North Dakota Department of Transportation

ADDENDUM 1 – JOB 2

TO: All prospective bidders on projects SOIA-7-085(096)192, Job No. 2 scheduled for the May 22, 2014 bid opening.

SRF No. 7594

Revised 5/12/2014	STATE	PROJECT NO.	SECTION NO.	SHEET NO.
	ND	SOIA-7-085(096)192	60	5

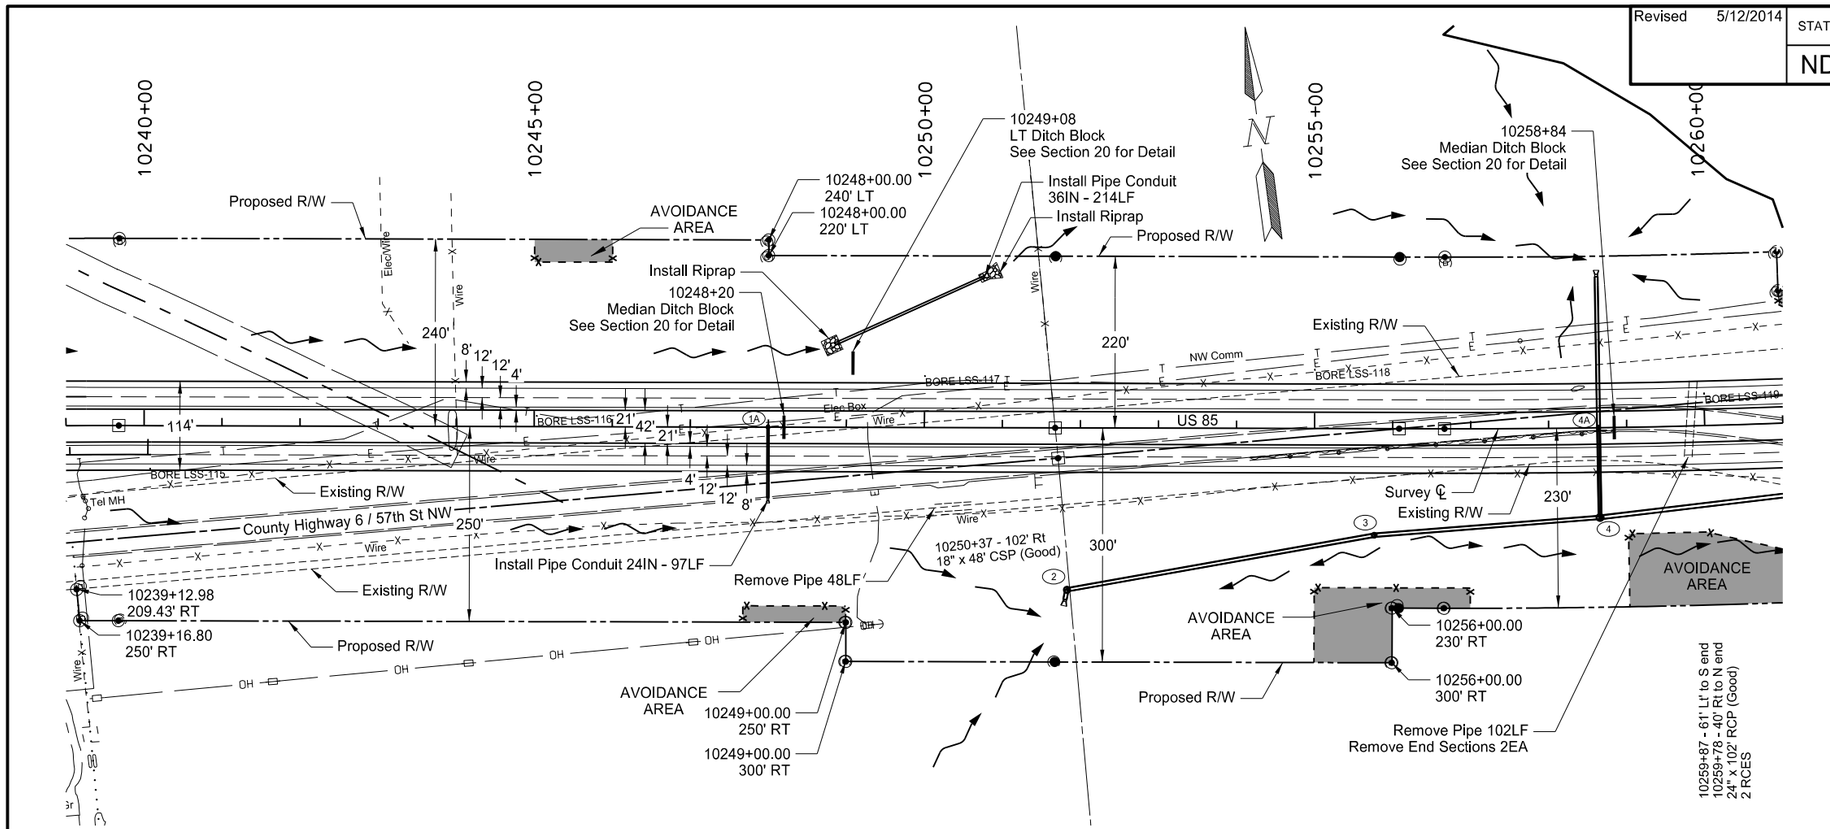
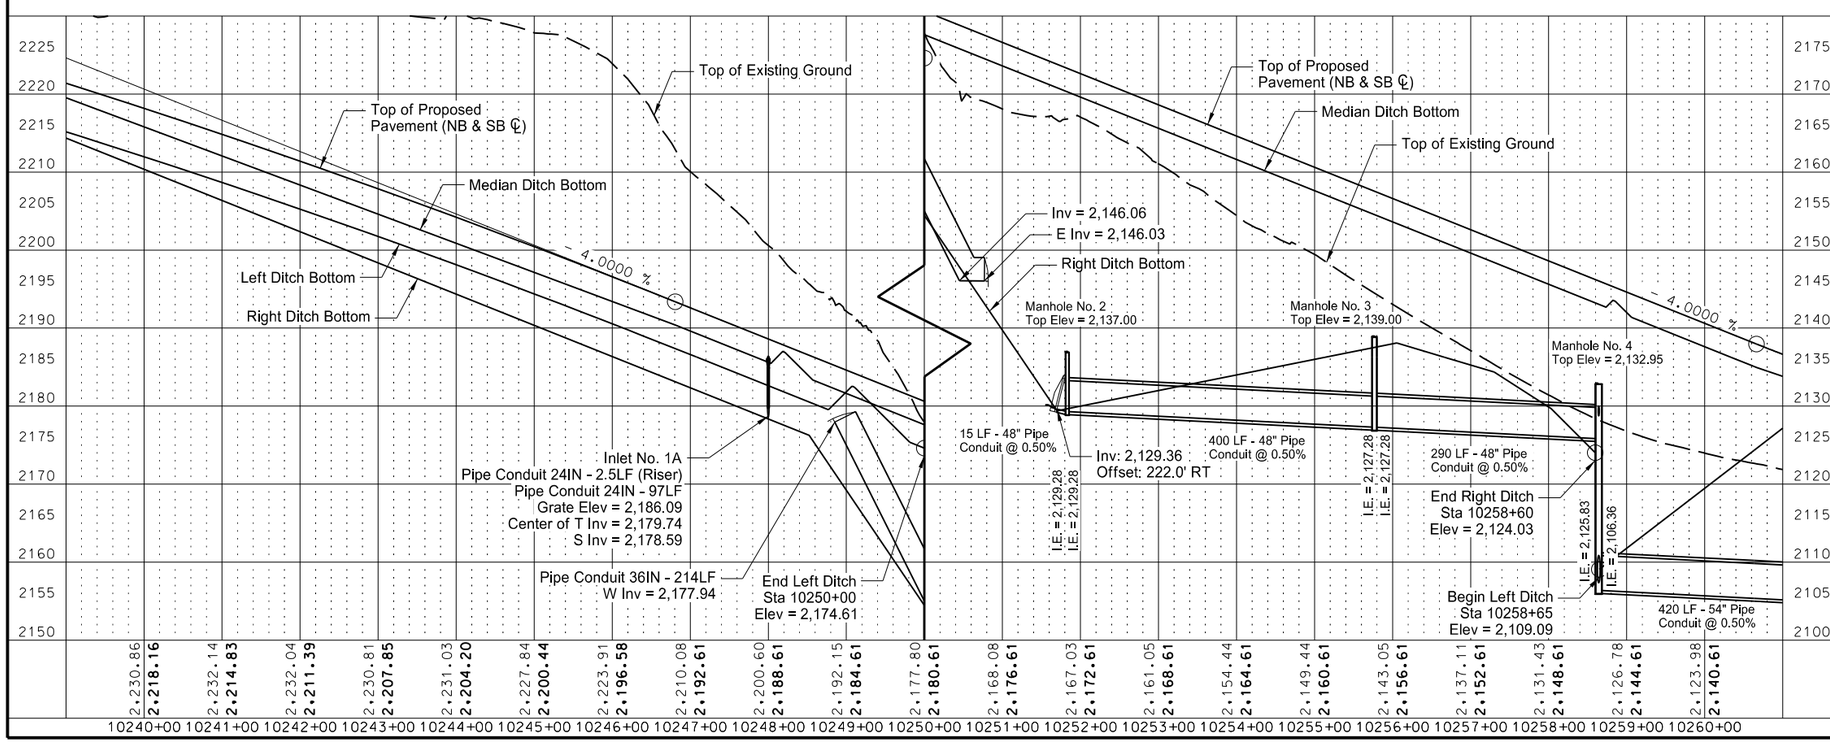
Sheet 60-5:
Revised due to change in retaining wall.

Revised 5/12/2014	STATE	PROJECT NO.	SECTION NO.	SHEET NO.
	ND	SOIA-7-085(096)192	60	6

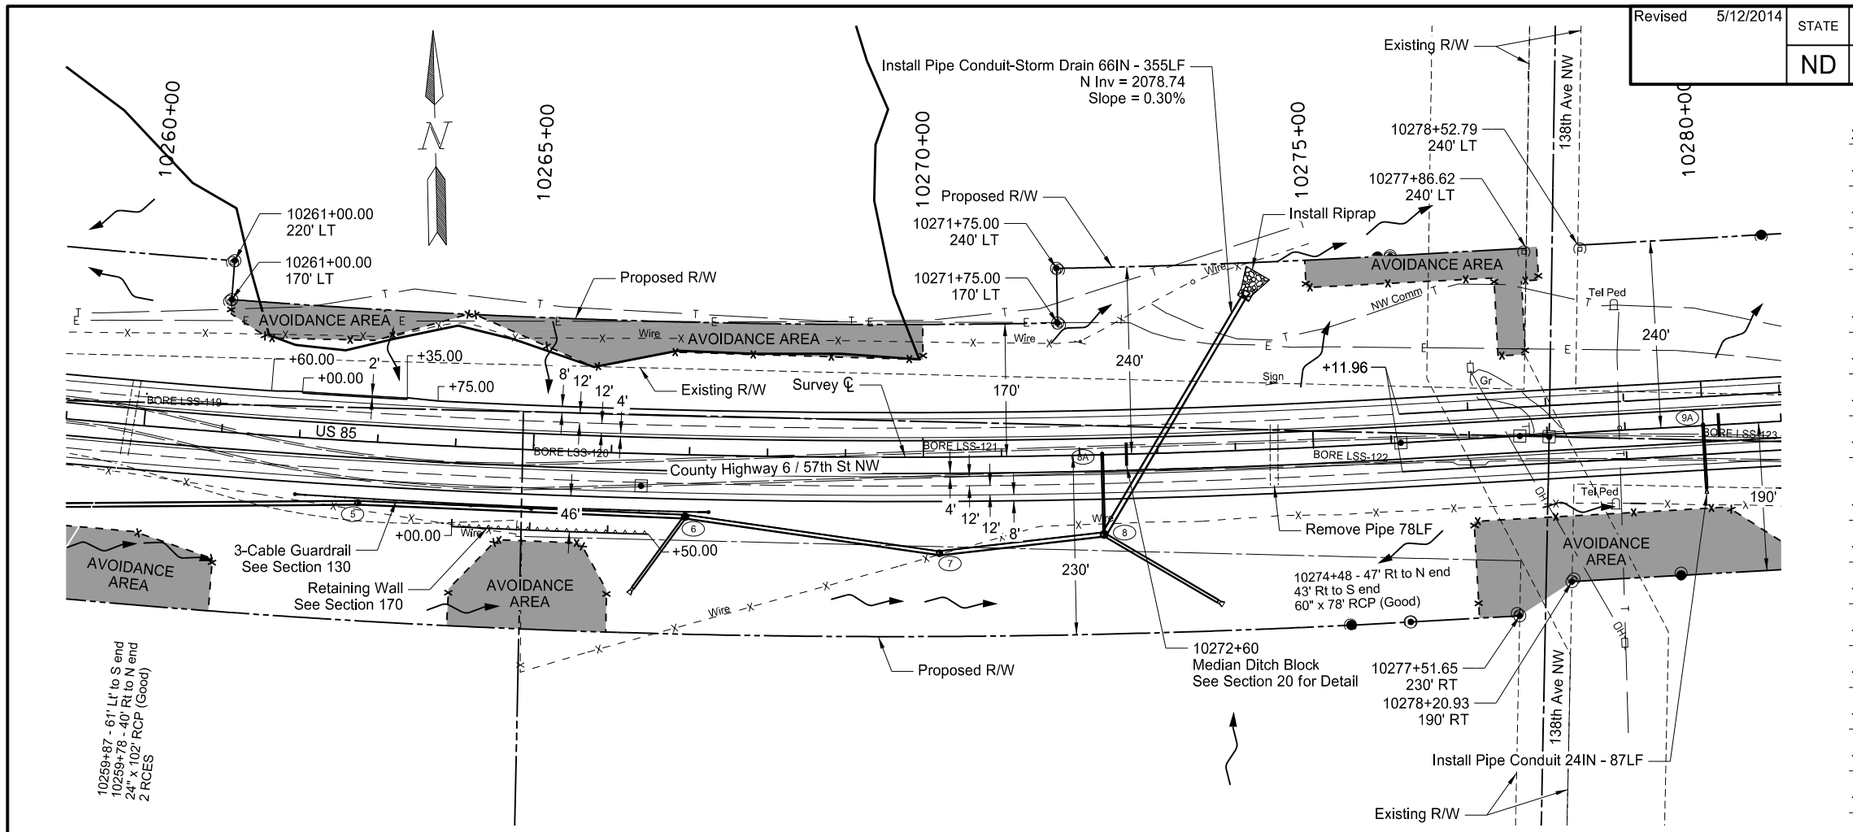
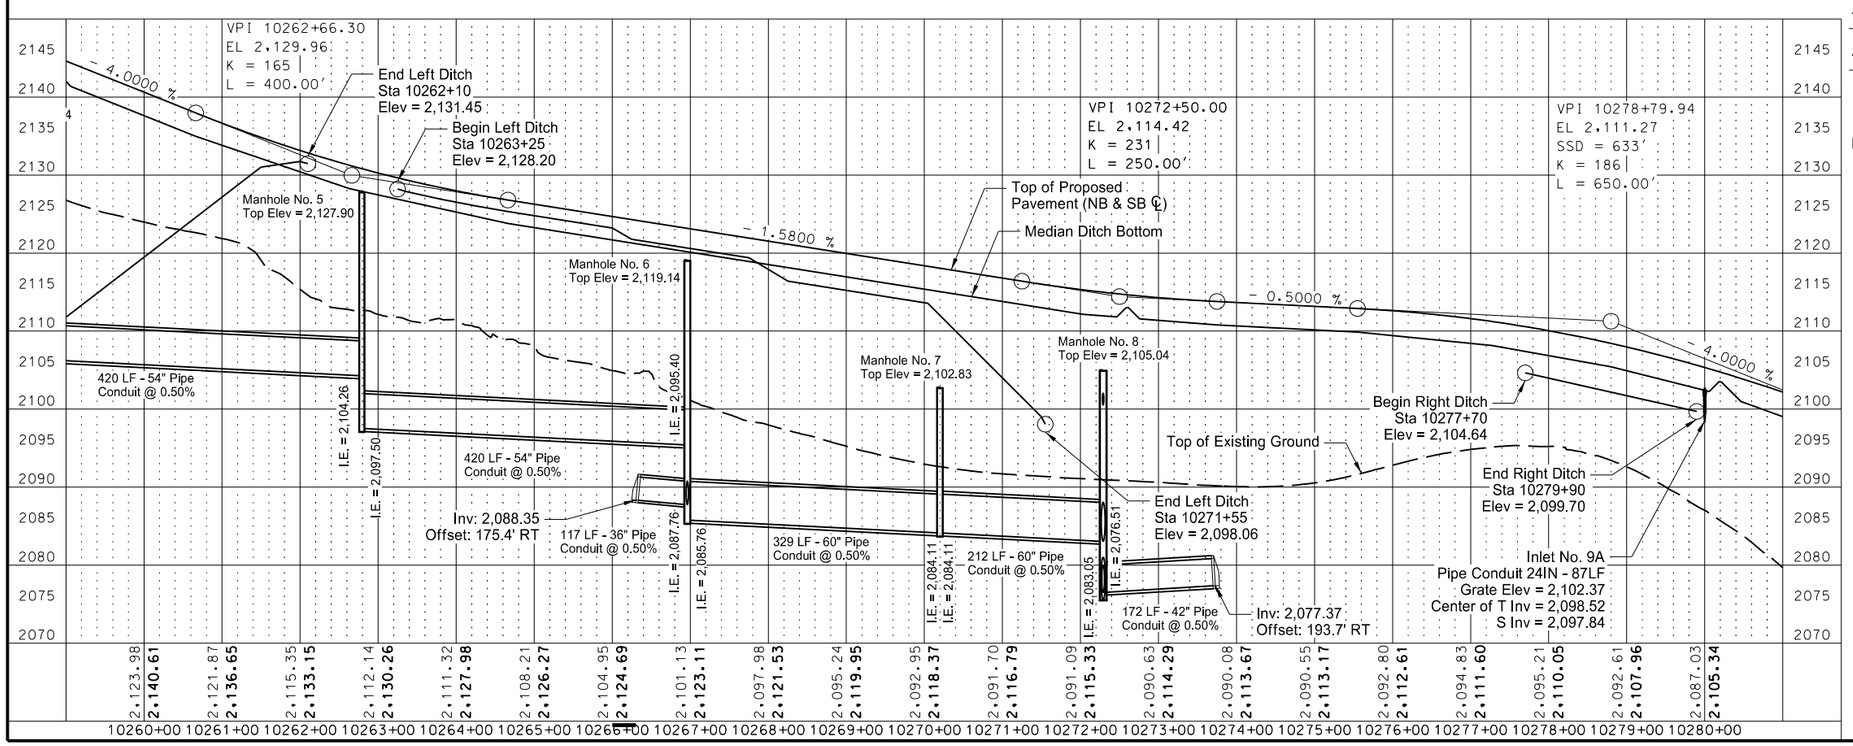
Sheet 60-6:
Revised due to change in retaining wall.

Revised 5/12/2014	STATE	PROJECT NO.	SECTION NO.	SHEET NO.
	ND	SOIA-7-085(096)192	60	29

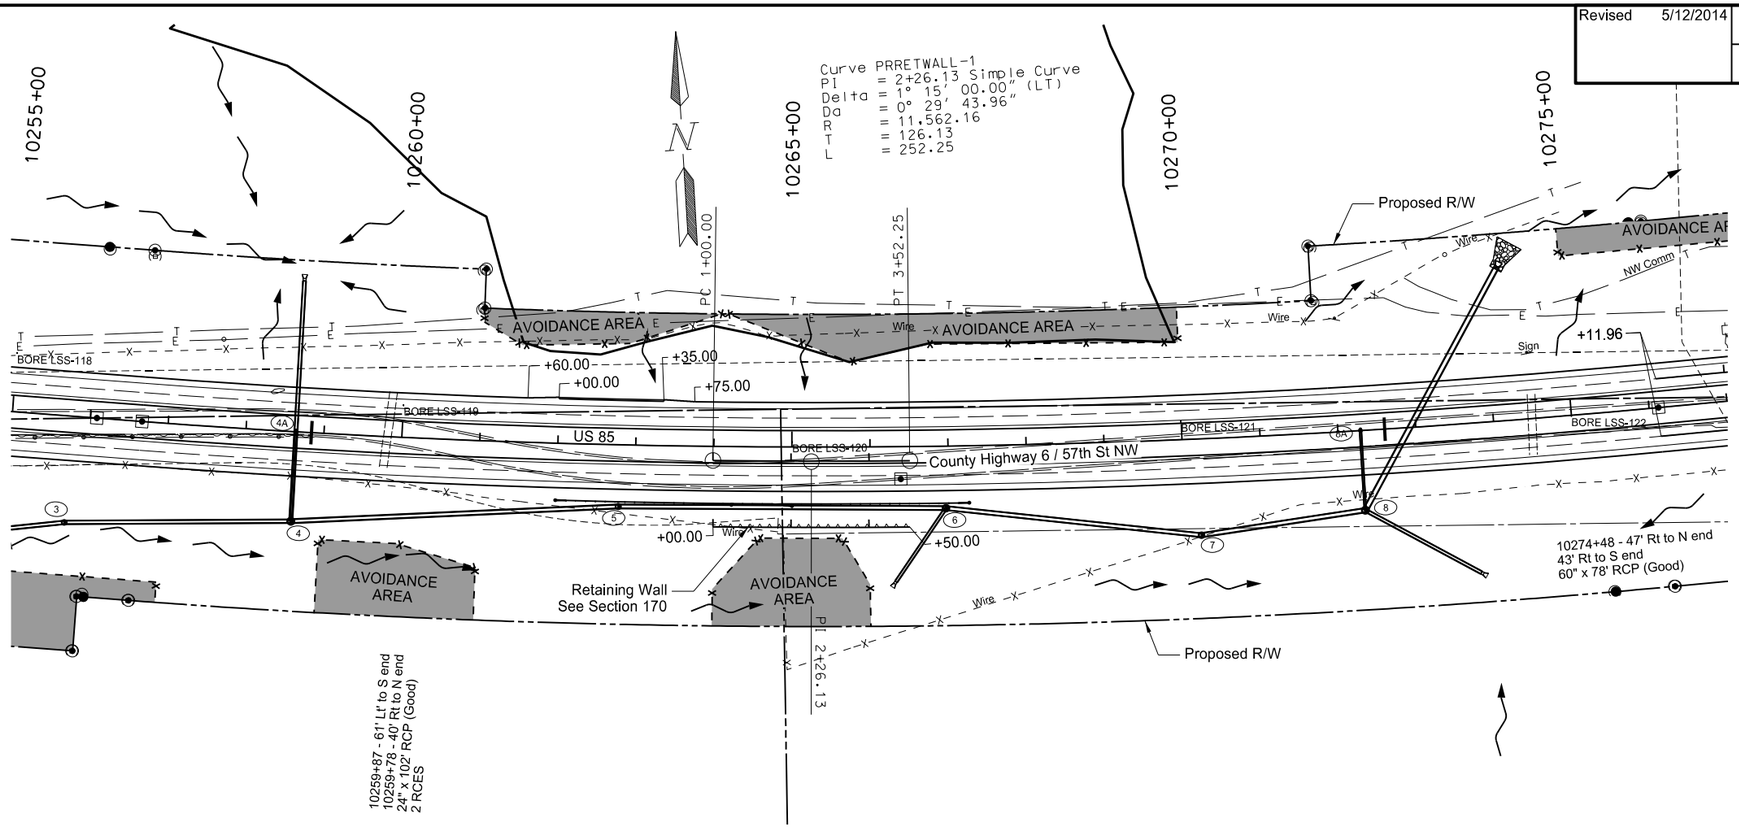
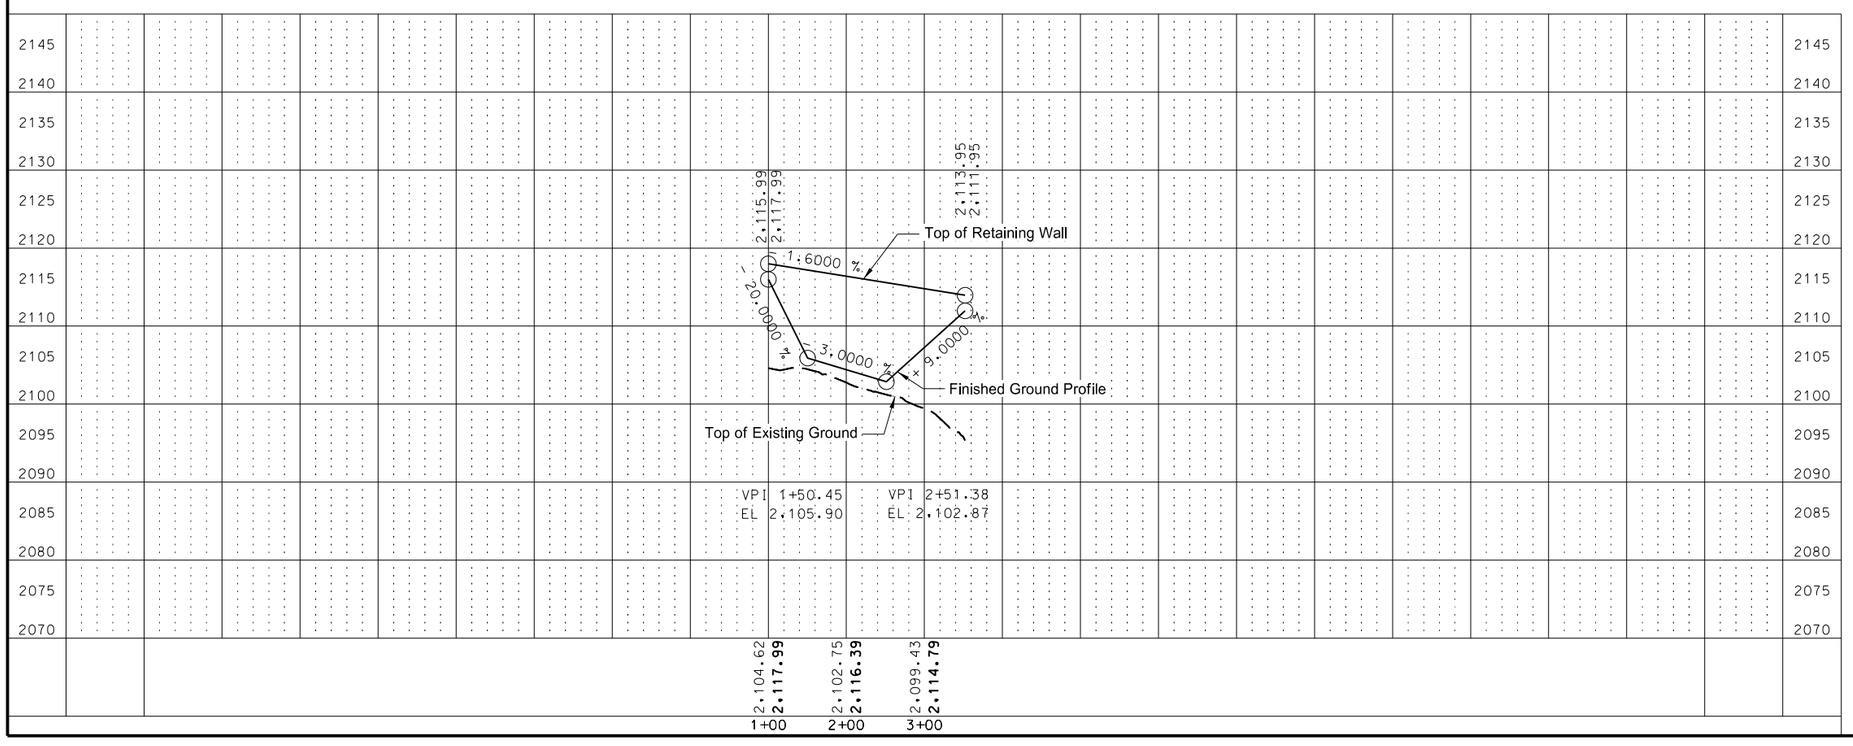
Sheet 60-29:
Revised retaining wall

Revised 5/12/2014	STATE	PROJECT NO.	SECTION NO.	SHEET NO.
	ND	SOIA-7-085(096)192	75	1

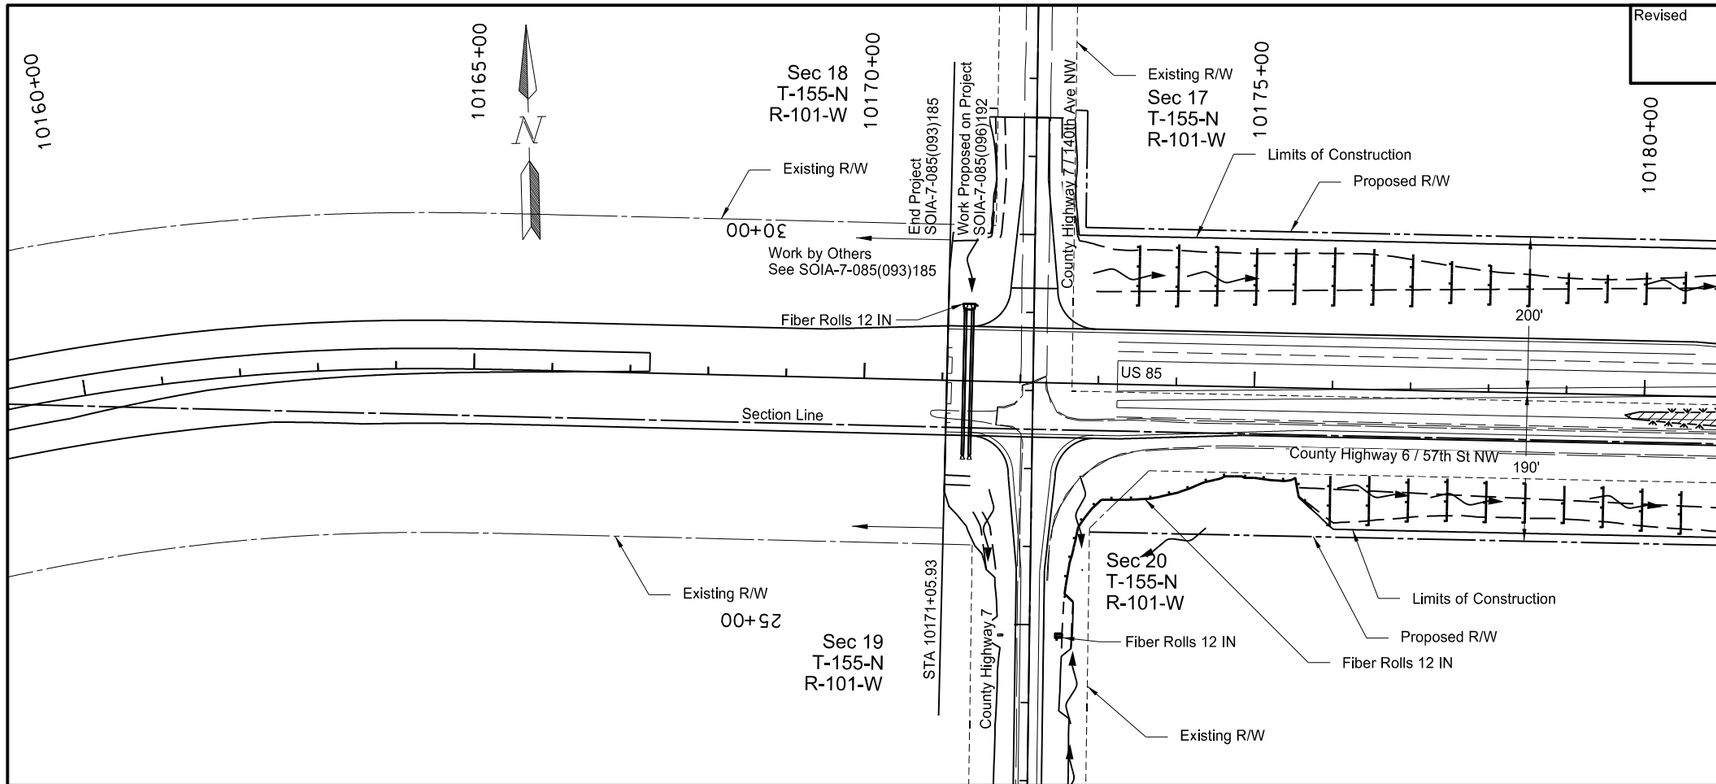
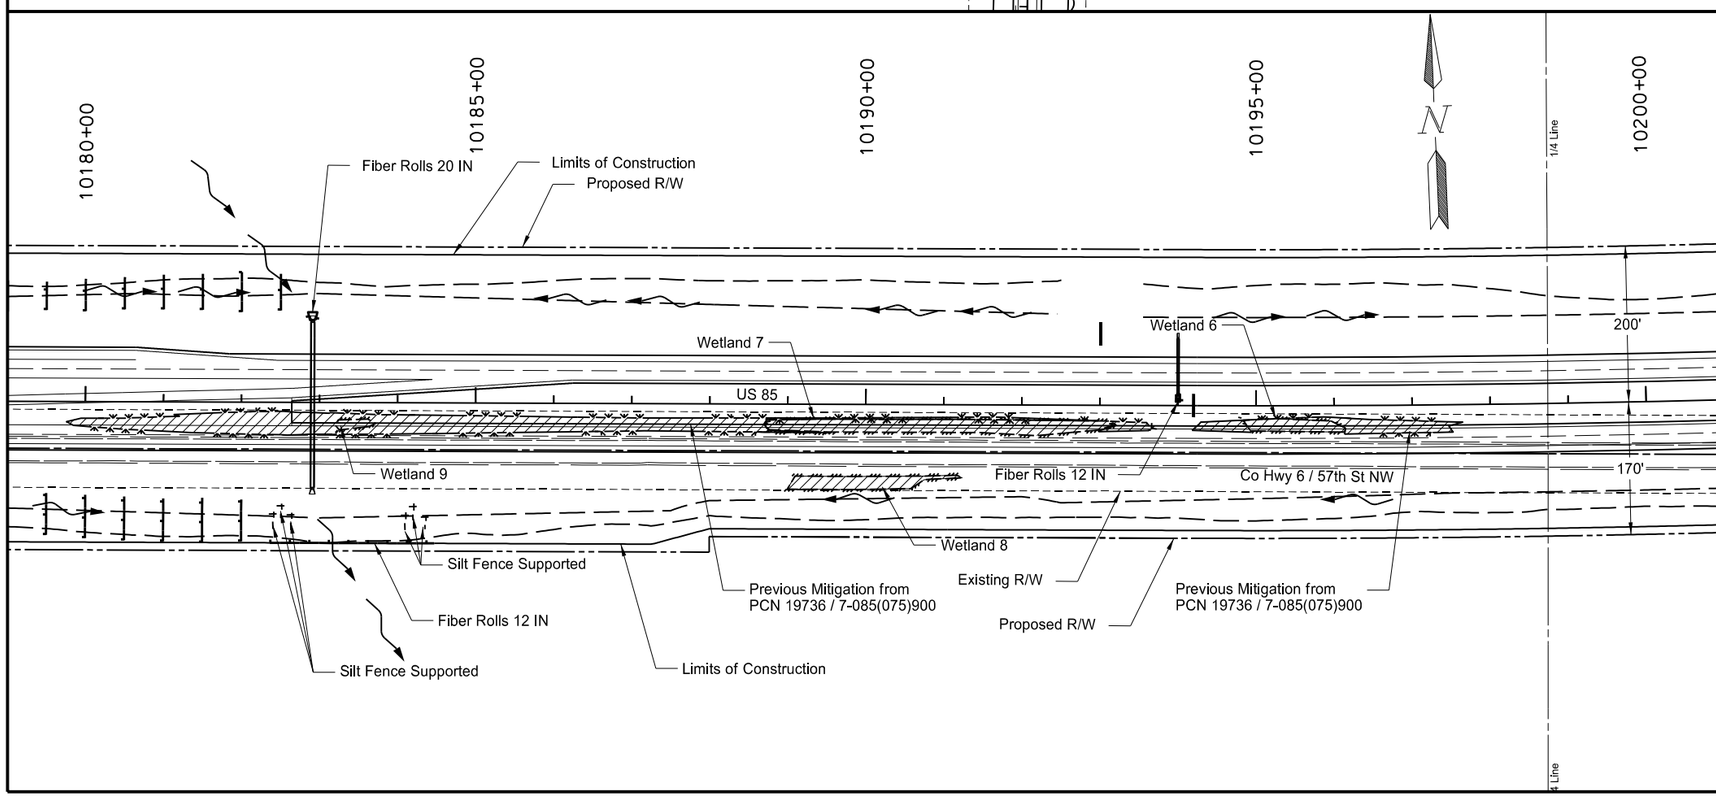
Sheet 75-1:
The center pipe size at station 10182+90 has changed
